RESPONSE TO AN BORD PLEANÁLA OPINION

Knockrabo Phase 2 Strategic Housing Development (SHD)

LANDS AT MOUNT
ANVILLE ROAD, DUBLIN
14

REF: ABP-309990-21

Figure 1 – Proposed Taking in Charge Plan, Drg No. 1307F-OMP-00-00-DR-A-1015 – Areas in blue to be taken in charge.

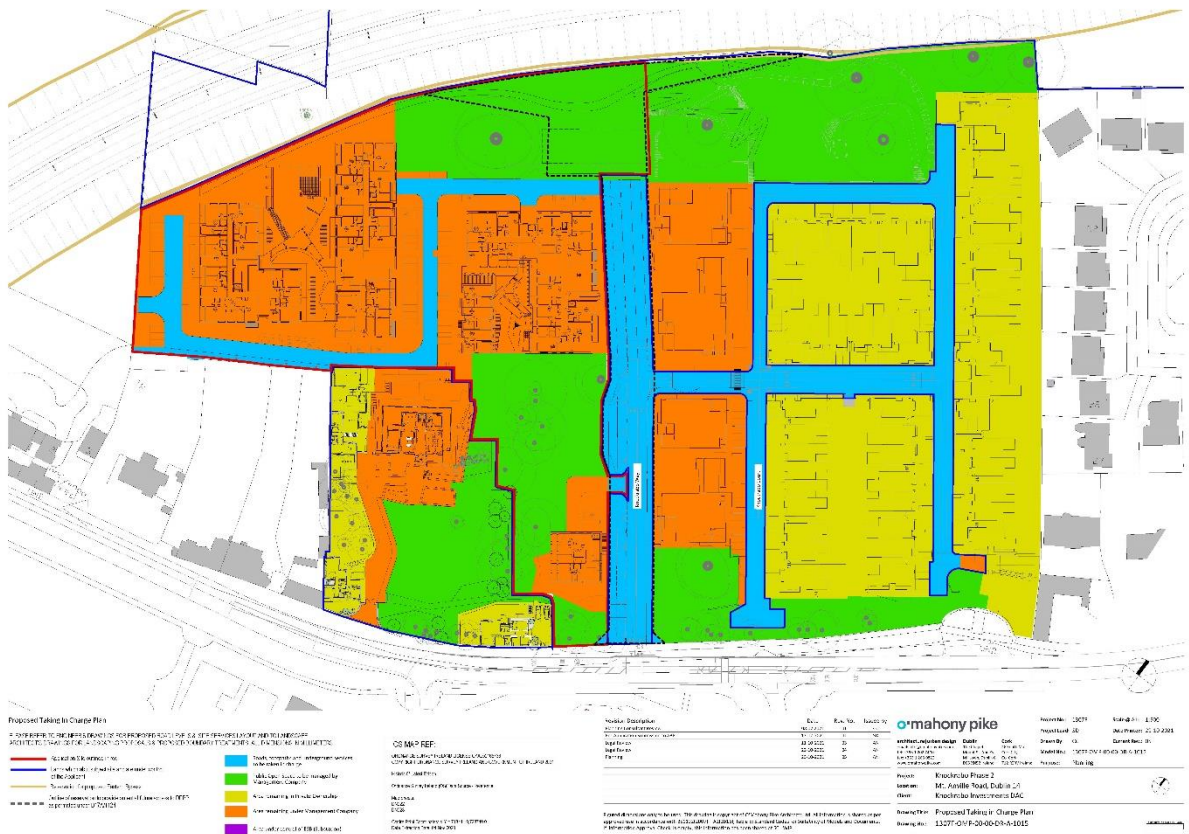
‘10. A site layout plan indicating what areas, if any, are to be taken in charge by the planning authority.’

Please refer to drawing No. 1307F-OMP-00-00-DR-A-1015 entitled Proposed Taking in Charge Plan prepared by OMP Architects, which comprises a site plan of areas proposed to be taken in charge by the planning authority. These areas were discussed and agreed with the planning authority as part of this Response.
